**FIRST ADDENDUM TO THE SUPPLEMENTAL
ENVIRONMENTAL IMPACT REPORT FOR THE OAKLAND
ARMY BASE AUTOMALL PROJECT**

**FIRST ADDENDUM TO THE
SUPPLEMENTAL ENVIRONMENTAL IMPACT REPORT
FOR THE OAKLAND ARMY BASE AUTO MALL
PROJECT**

**ADDRESSING PROJECT CHANGES RELATED TO SITE LAYOUT AND
ADDITIONAL INFORMATION ON TRAFFIC AND WASTEWATER**

December 2007

Figure 2: SEIR Compact Design Alternative with Mitigated EBMUD Driveway

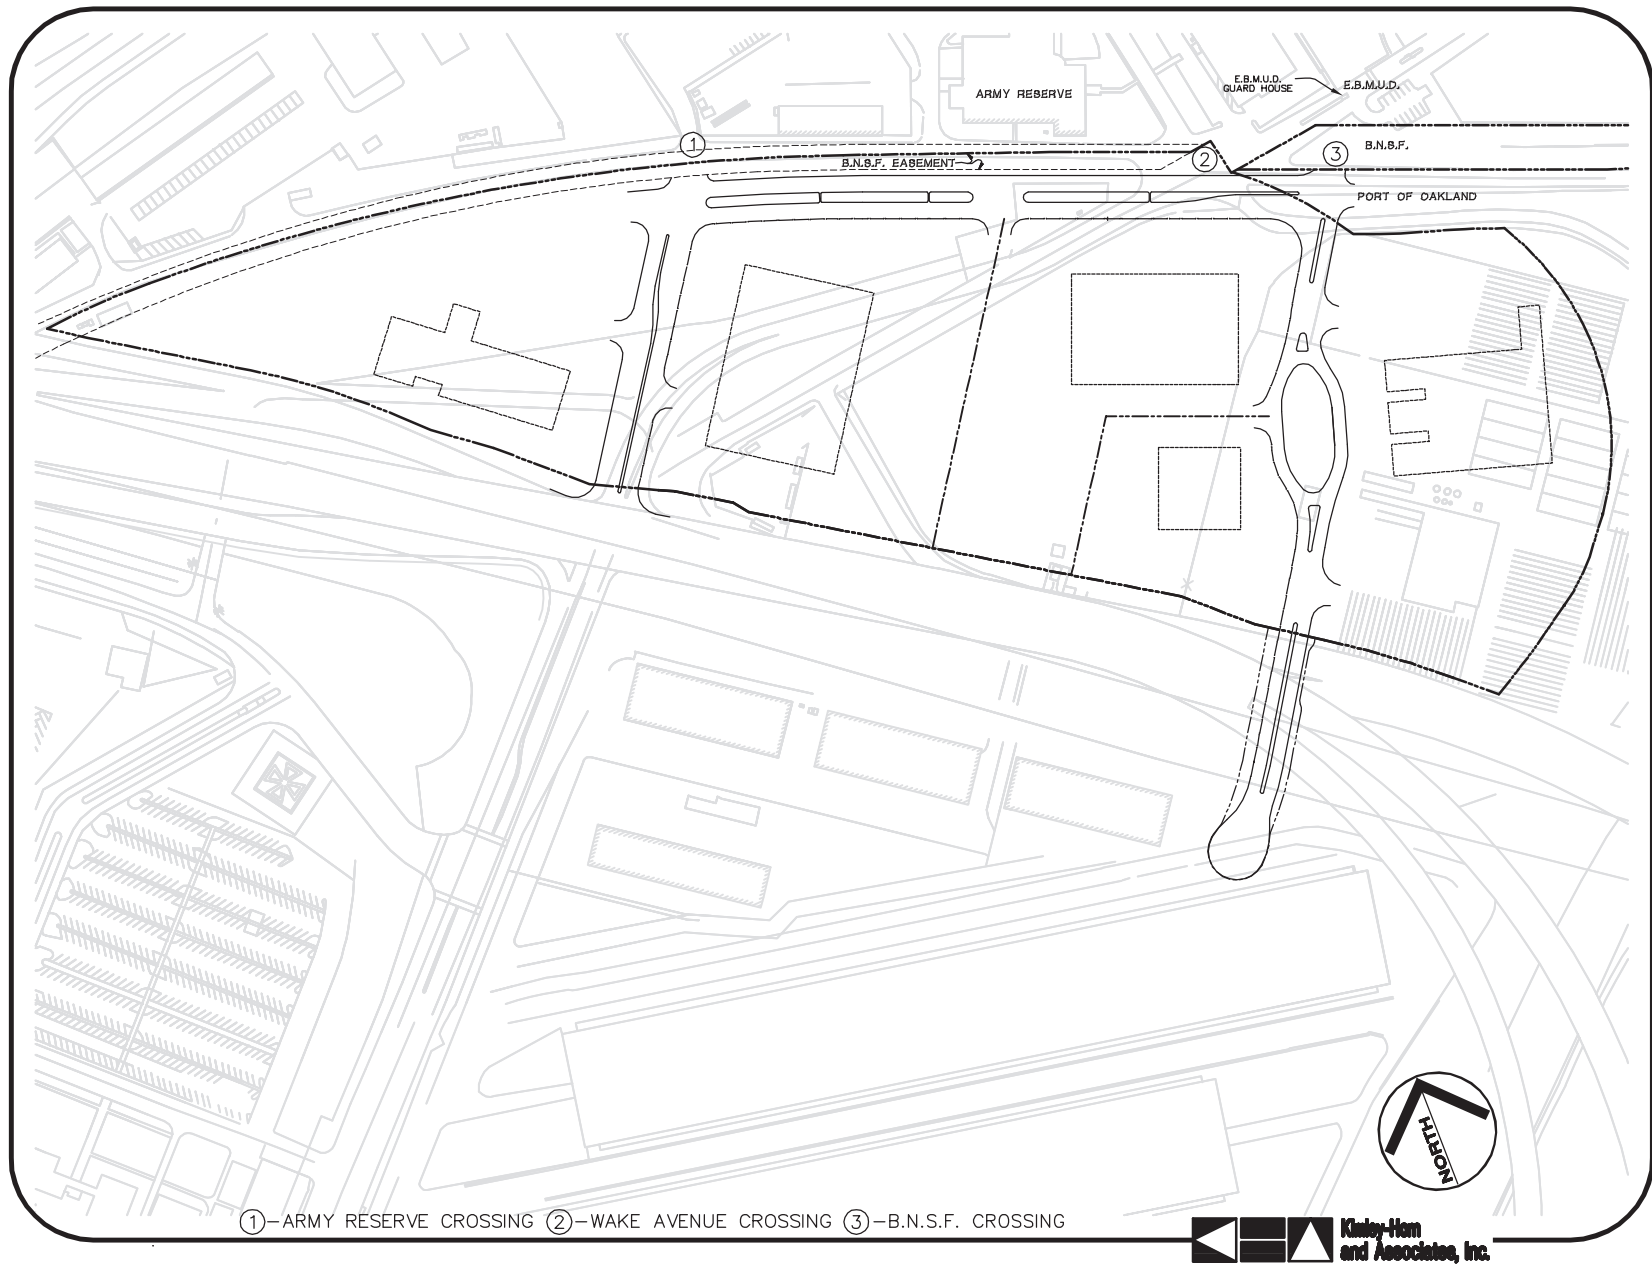
- **One option** [emphasis added] would be to relocate the EBMUD driveway to connect as the north leg of the North Access Road/East Access Road intersection. If the driveway were relocated, the North Access Road/ East Access Road intersection would operate in compliance with the City’s level of service standards with all-way stop traffic control.

A preliminary design of this access option is shown in **Figure 2**, combined with the SEIR Compact Design Alternative. This mitigation measure was found to reduce potential design hazard impacts to a less than significant level.

The specific access options included in the SEIR has since been determined infeasible (see Other Access Options Considered but Rejected, below). However, new access options have been developed. The ability of these access options to provide reasonable and safe access is analyzed in the following section of this Addendum.

Figure 3: Addendum Project Description

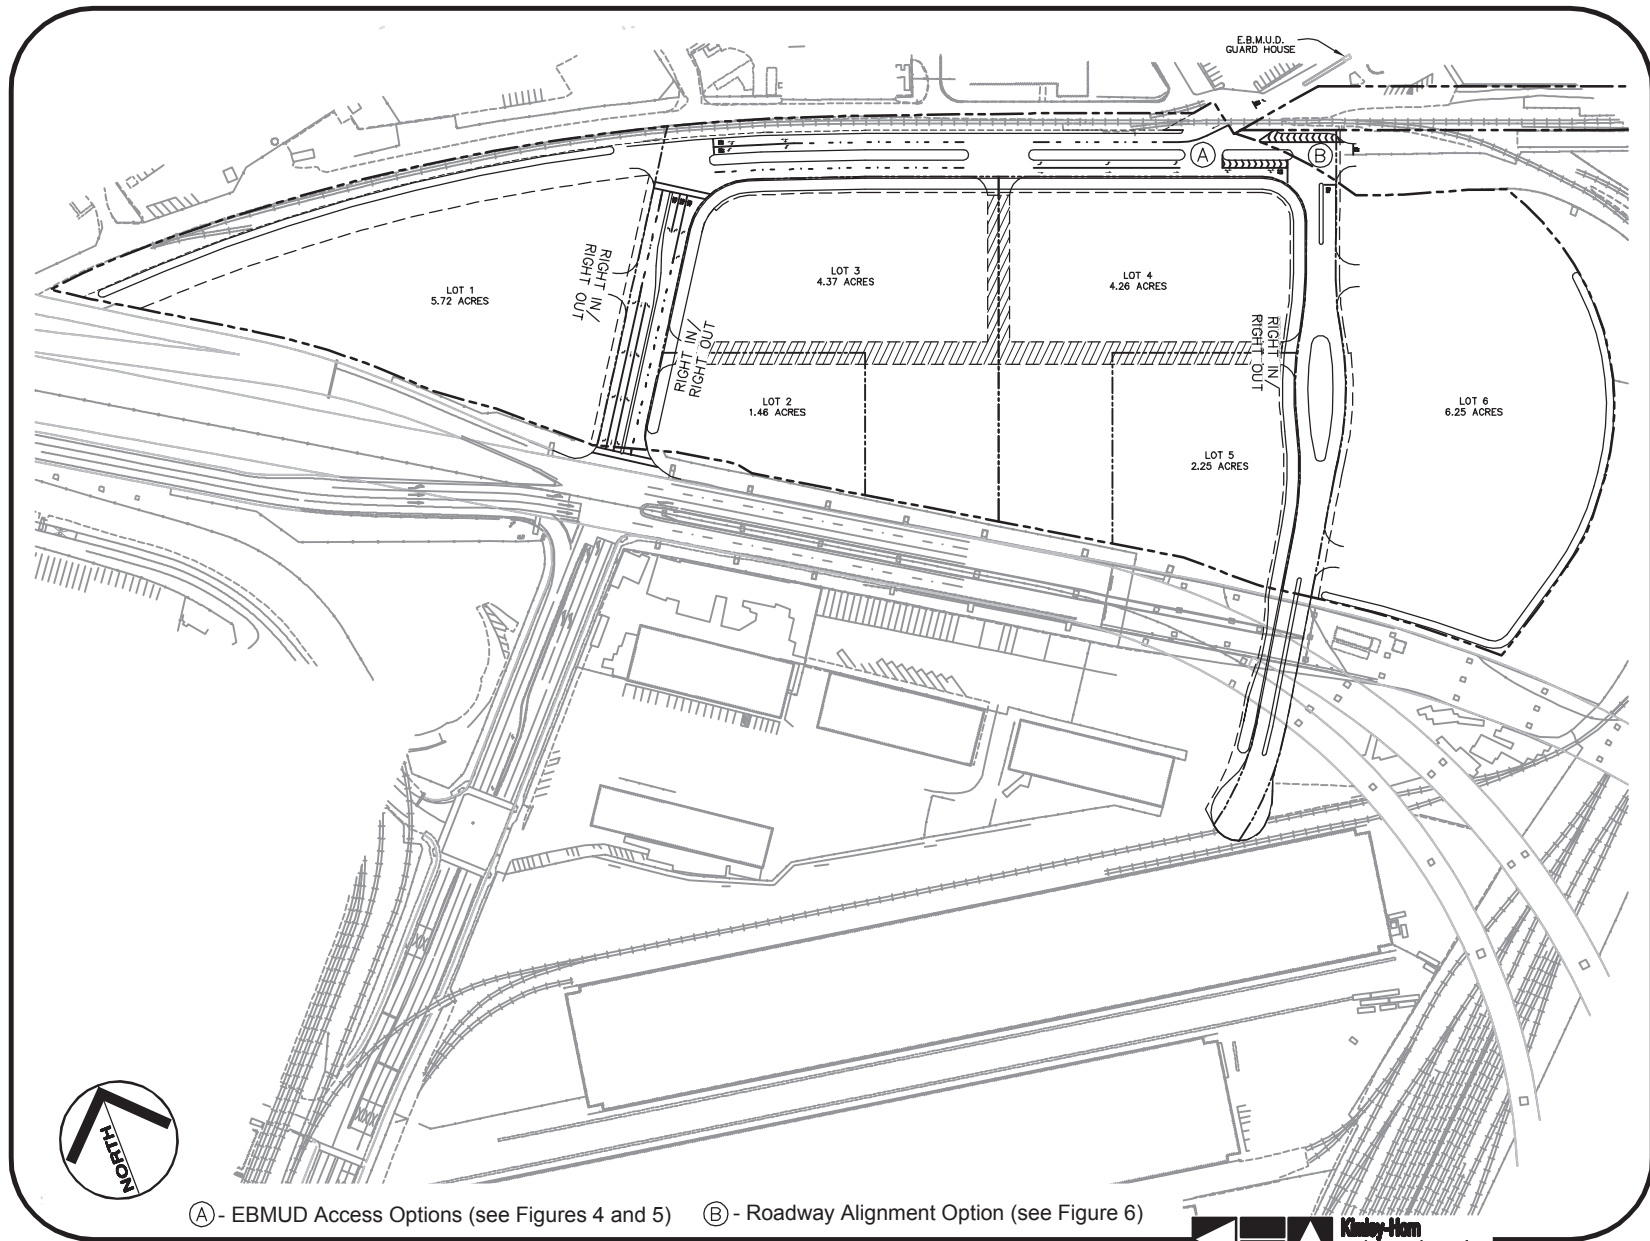
Internal reconfiguration of the lots is possible to accommodate final dealership plans but will substantially conform to the project description. Lot reconfiguration could lead to slight shifting of the driveways from that shown in Figure 3. Access to/from these driveways will be shared among the dealerships in the central lots (those labeled Lots 2, 3, 4 and 5 in Figure 3) and will be limited to one on the western boundary with the Maritime Street extension, one on the northern boundary with the North Access Road, and one on the eastern boundary with the East Access Road. To simplify traffic movements, turning movements will be limited to right in/right out only for three of the Auto Mall driveways, as indicated on Figure 3, but otherwise it is anticipated no other turning movements will be prohibited. The specific location of driveways and final designs of the roadways are subject to approval of the City of Oakland's Transportation Services Department.

While the SEIR identified one optional intersection configuration as mitigation to address the **potential** design hazards at the EBMUD access intersection, other possible intersection design options are now considered as more feasible. These other possible options are shown in **Figure 4**: EBMUD Access - Dedicated Left Turn Lane Option and **Figure 5**: EBMUD Access - Left Turn Pocket Option. The following Traffic chapter of this Addendum includes analysis of these options for providing access to the neighboring EBMUD facility to ensure reasonable and safe access.

Figure 4: EBMUD Access - Dedicated Left Turn Lane Option

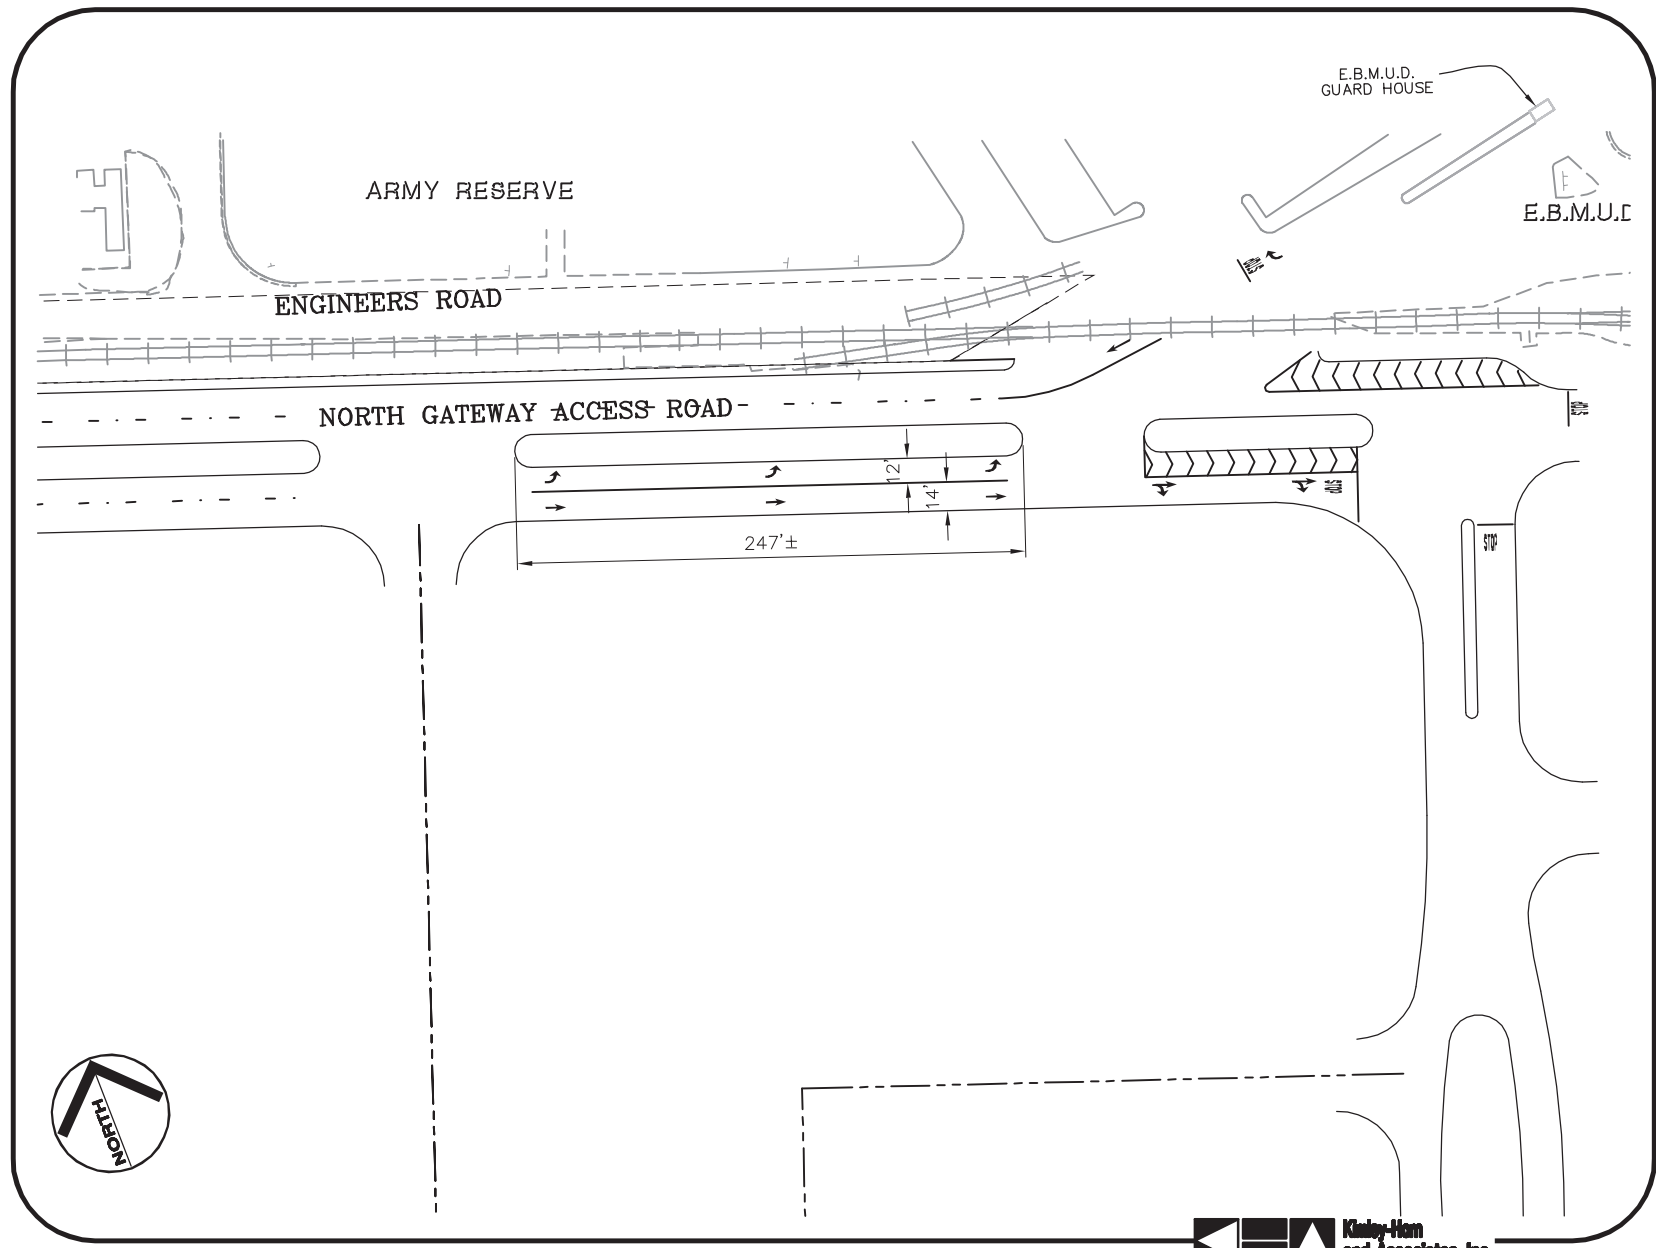
The Dedicated Left Turn Lane option (Figure 4 on p.11) represents a refinement of the less-well-defined intersection geometry evaluated in the SEIR. The Dedicated Left Turn Lane option is described as follows:

- The eastbound lanes on the North Access Road would include one dedicated left turn lane into the EBMUD driveway and one shared through/right turn lane. The relatively light volume of through and right turn traffic would be easily accommodated in one shared lane. A median would separate eastbound and westbound lanes. The dedicated left turn lane would provide 250 feet of storage for vehicles entering the EBMUD driveway beyond the first median break, and additional storage as far back as the Maritime

The Dedicated Left Turn Lane option would include a stop location to the north of the rail line for vehicles exiting the EBMUD driveway, a location which would provide adequate lines of sight for vehicles using the North Access Road/EBMUD driveway intersection. This option would not change the existing skewed rail crossing at the EBMUD driveway. The skewed rail crossing is less than ideal in its existing state because southwest-bound drivers approaching the EBMUD driveway would have a difficult time seeing a train approaching over their left shoulder from behind. The skewed rail crossing has not been identified as a high priority for remediation due to the slow speed of trains using this rail line (maximum 10 mph), the low volume of both motor vehicle and train traffic, and the lack of any known accidents at this location under these conditions. There is no reason to believe development of the Auto Mall project would have any effect on the safety of this skewed rail crossing. The Dedicated Left Turn Lane option does not make the existing skewed crossing any safer or less safe than current conditions because it does not change the existing angle of the crossing.

The dedicated left turn lane would provide more than adequate storage capacity to accommodate the maximum anticipated design queue at the North Access Road/EBMUD driveway intersection. The dedicated left turn lane and the combination through/right turn lane would each serve fewer than 300 vehicles during the peak hour. The vast majority of both EBMUD and auto mall traffic would be automobiles and both uses would accommodate

Figure 5: EBMUD Access - Left Turn Pocket Option

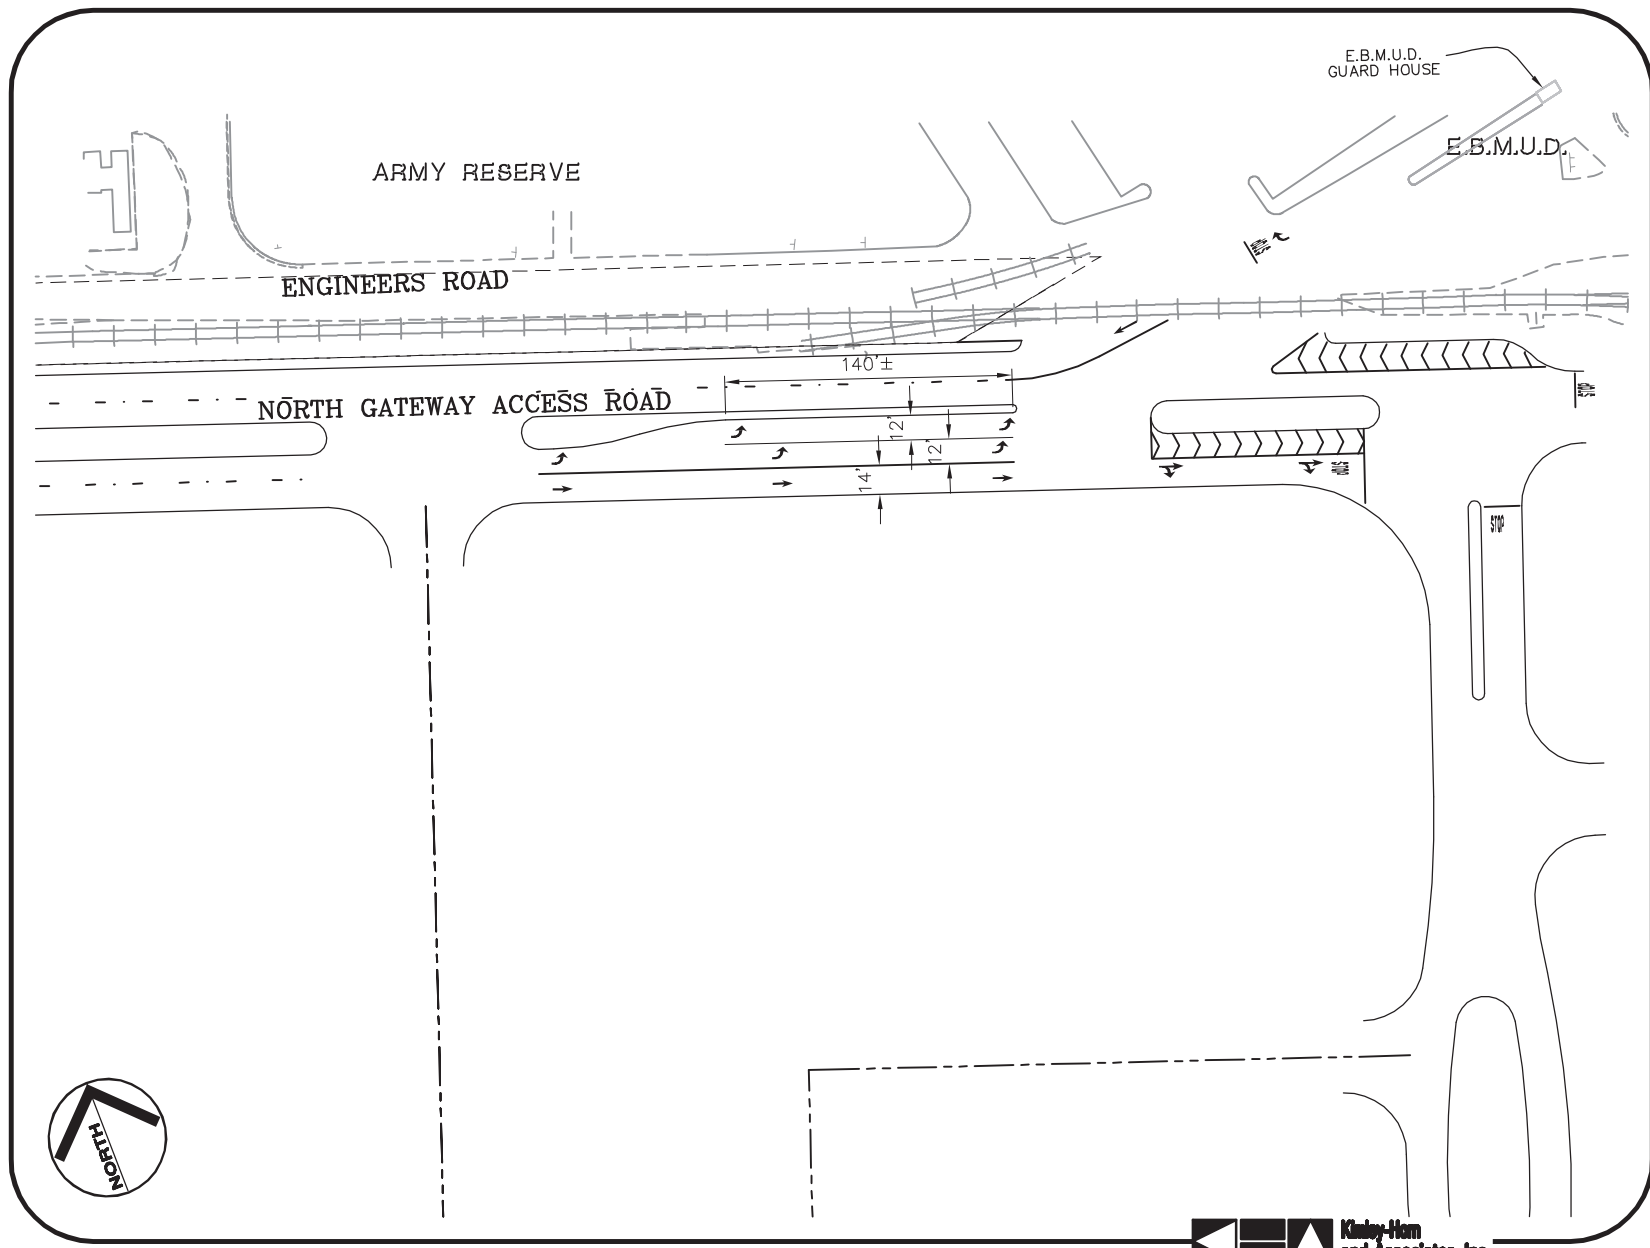
The Left Turn Pocket option (Figure 5 on p.12) represents a modification to the Dedicated Left Turn Lane option. The purpose of this modification is to consider an access design that accommodates EBMUD's stated preference for dual left turn movements into their driveway. The Left Turn Pocket option would be the same as the Dedicated Left Turn Lane option with the following exception:

As with the Dedicated Left Turn Lane option, this design option would maintain all existing driveways north of the rail crossing and would provide adequate lines of sight for vehicles using the North Access Road/EBMUD driveway intersection. The stop location for traffic exiting the EBMUD driveway would be located north of the BNSF spur tracks and would place exiting vehicles in a position to see vehicles approaching from all directions.

The Left Turn Pocket option would not change the existing skewed rail crossing at the EBMUD driveway. As with the Dedicated Left Turn Lane option, the Left Turn Pocket option does not make the existing skewed crossing any safer or less safe than current conditions because it does not change the existing angle of the crossing.

The Left Turn Pocket option would provide approximately 140 feet of storage in a dedicated left turn pocket for vehicles entering the EBMUD driveway in addition to a second left turn lane with more than 700 feet of storage capacity. As stated above, the 95th percentile design queue would be approximately 200 feet to accommodate the queue that could form in the

event of a 2-minute train blockage. Thus, the Left Turn Pocket option would provide more than sufficient storage capacity to accommodate the design queue.
